REQUEST FOR BIDDING INTERPRETATION (RFBI)

PMDB RFBI No.: 24

Project No.: 000000000008666
Project Name: DSH-Coalinga Hydronic Loop Replacement
Location: Coalinga, CA

Drawing Reference: Sheet S-3.00 Project Manual Reference: _____

4 DETAIL

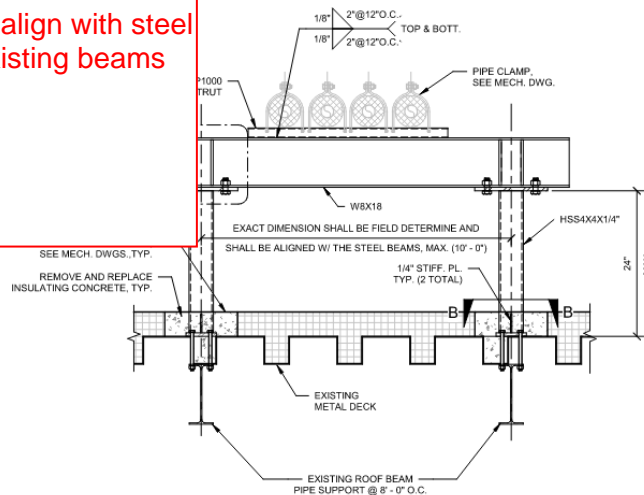
Question: Please confirm that all the roof pipe supports need to align with the steel roof beams as shown below.

If so, please confirm that the Owner will locate the position of the existing beams on the roof.

The roof pipe supports needs to align with steel roof beam. For location of the existing beams coordinate with the owner.
